dsPIC33FJ06GS101/X02 and dsPIC33FJ16GSX02/X04 Family Silicon Errata and Data Sheet Clarification

The dsPIC33FJ06GS101/X02 and dsPIC33FJ16GSX02/X04 family devices that you have received conform functionally to the current Device Data Sheet (DS70000318G), except for the anomalies described in this document.

FIGURE 1: TIMING DIAGRAMS FOR CENTER-ALIGNED AND EDGE-ALIGNED MODES

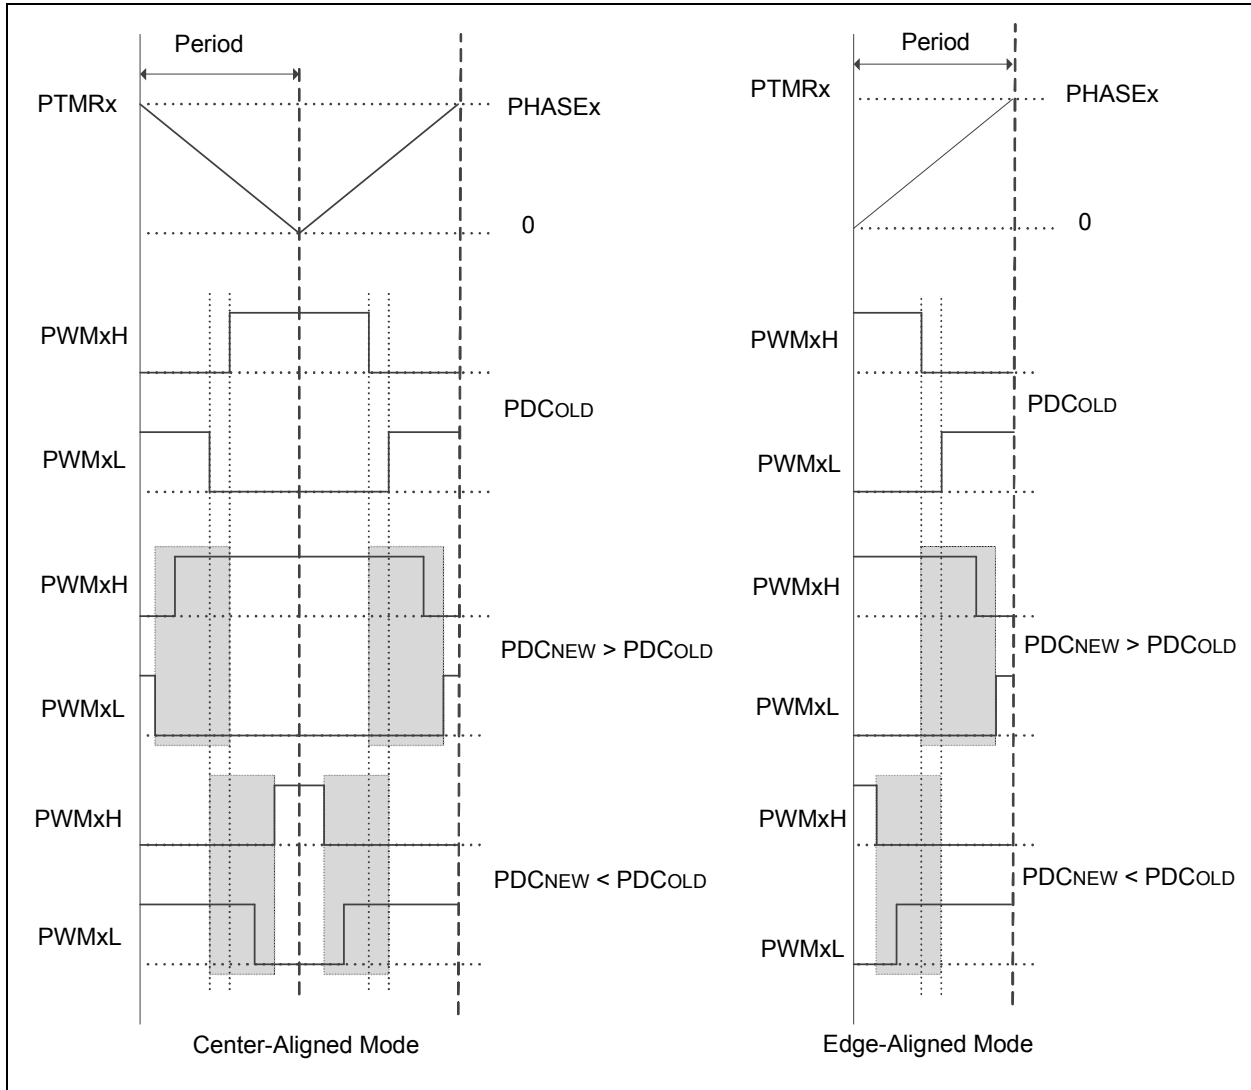
The PWMx generator may not assert dead time on the edges of transitions. This has been observed when all of the following conditions are present:

In [Figure 1](#) (following page), if the duty cycle write occurred in the shaded box, then PWMxH and PWMxL will make an immediate transition without dead time.

FIGURE 2: ISSUE EXAMPLE FOR REDUNDANT OUTPUT MODE

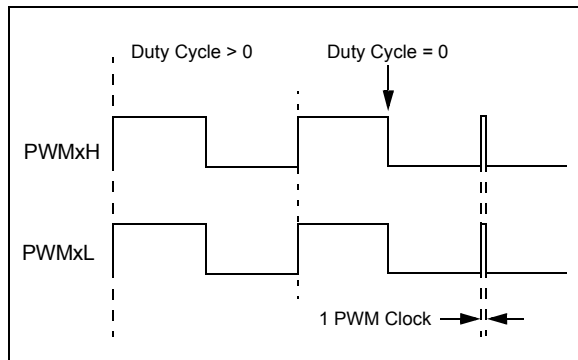
In Redundant Output mode (IOCONx<11:10> = 01) and Push-Pull Output mode (IOCONx<11:10> = 10), with the Immediate Update disabled (PWMCONx<0> = 0), when the Duty Cycle register is updated from a non-zero value to zero, a glitch pulse of a width equal to 1 PWM clock will appear at the next PWM period boundary, as shown in Figure 2 (for the Redundant Output mode). The Duty Cycle register refers to the PDCx register if PWMCONx<8> = 0 or the MDC register if PWMCONx<8> = 1.
